## Interactive comment on "Water vapour total columns from SCIAMACHY spectra in the 2.36 $\mu$ m window" by H. Schrijver et al.

## H. Schrijver et al.

Received and published: 10 September 2009

**Fig. 1.** Example of measured spectrum and fit. Dead and bad detector pixels have been blinded. The modelled spectrum is also shown for most bad pixels, but for some pixels it is absent for technical reasons.

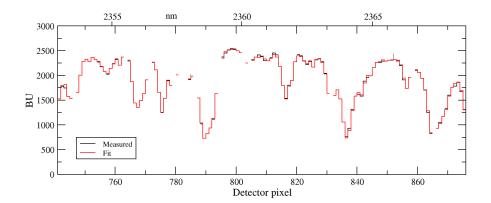
- A sample spectral fit could be shown.

We felt that such a figure would not be very illustrative, because of the large number C520

of dead and very noisy detector pixels, that would disturb the figure. We have appended an example to this comment with the bad pixels blinded which may give some impression of the fit quality.
